Submission by Robert H. McNaught of the Astronomical Society of Coonabarabran

SUMMARY

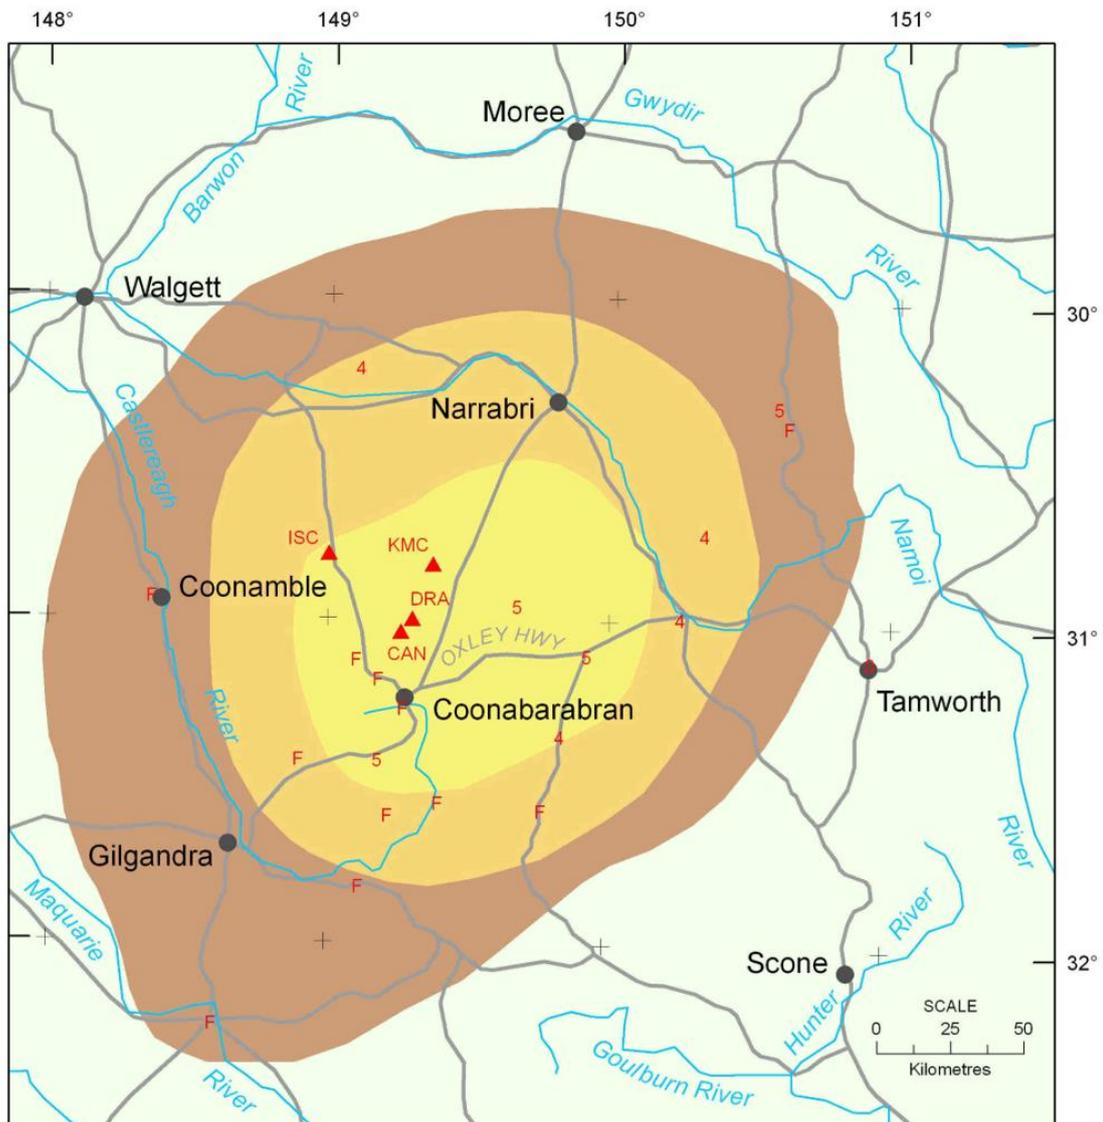
Phillips ^{ref 11}. In 2011, Prof K. McCue ^{ref 12} assessed first hand reports of damage

and ground movement for this earthquake and reanalysed all available

seismometer traces to produce the intensity map below. The southern part of

the Narrabri gas project is within the region of M5 intensity, with the SW

corner of the project area ~45km from the epicentre.

Similar features in the paleo-record. e.g. Walgett

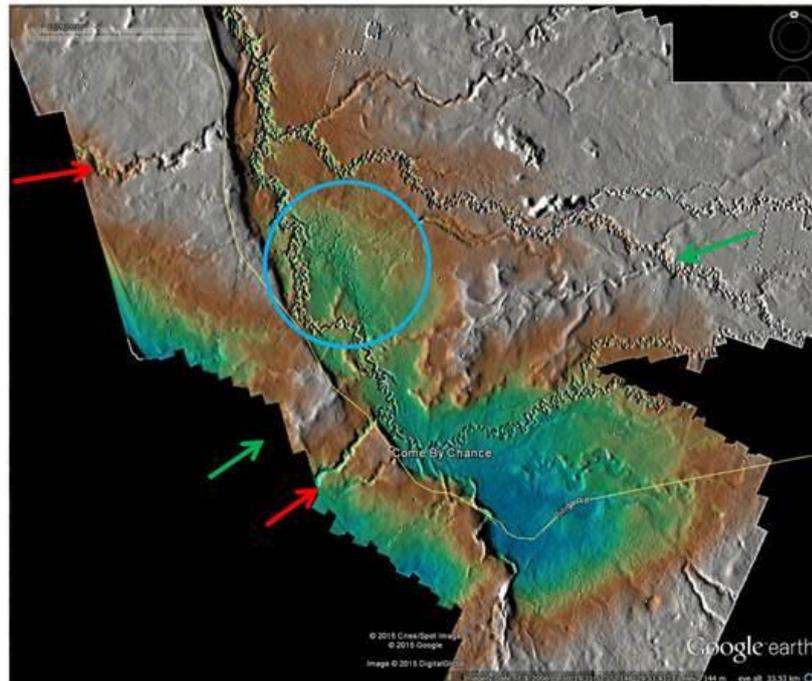
>55km long
~2.5 m high
Mw7.2 EQ?

The historical watercourses west of the scarp (arrowed in the above image, courtesy of Dr D. Clark, Geosciences Australia) are still visible from the air, indicating a very young geological age (likely less than tens of thousands of years, but as yet unstudied). The magnitude of this event would have been of the order of M7 and would have caused widespread damage across the general region, including the project area. The section of the fault to the

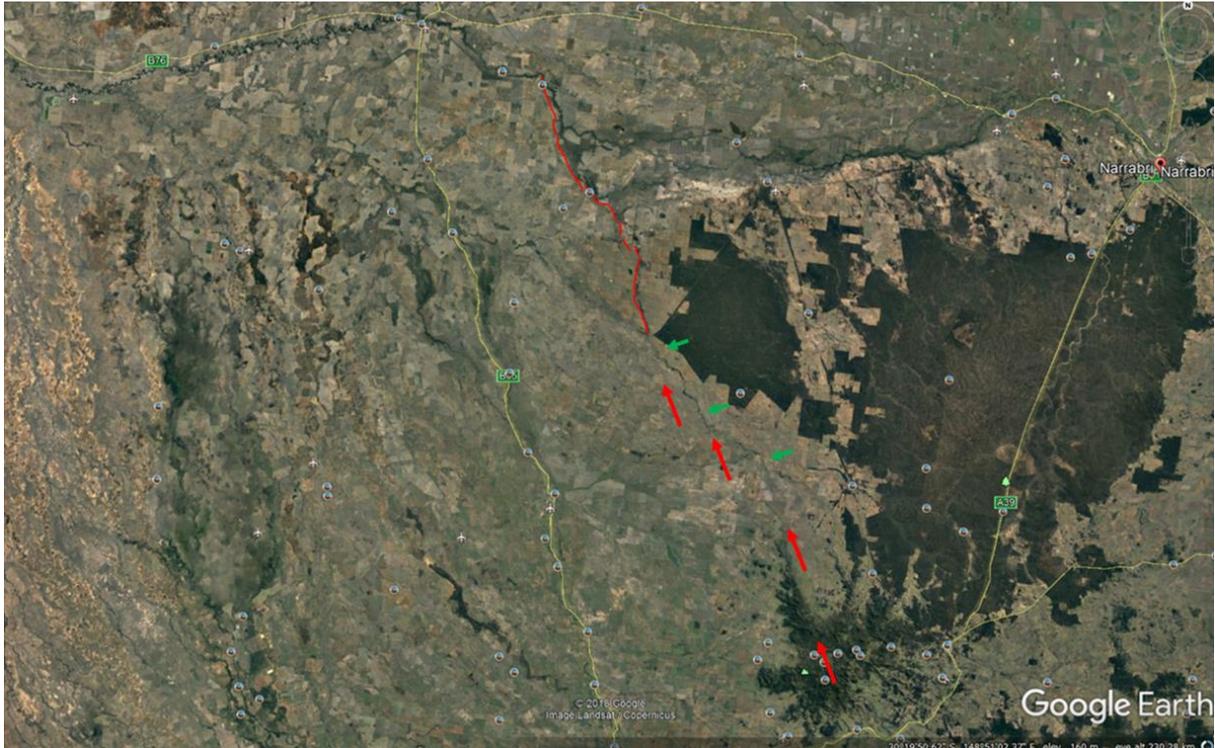
A more recent analysis of Lidar data by Dr Clark, indicates a 63km total length for the Walgett scarp. Additionally, linear features (arrowed in the image below, courtesy of Dr D. Clarke, Geosciences Australia) suggest the extension of the fault line SE into the Warrumbungle mountains.
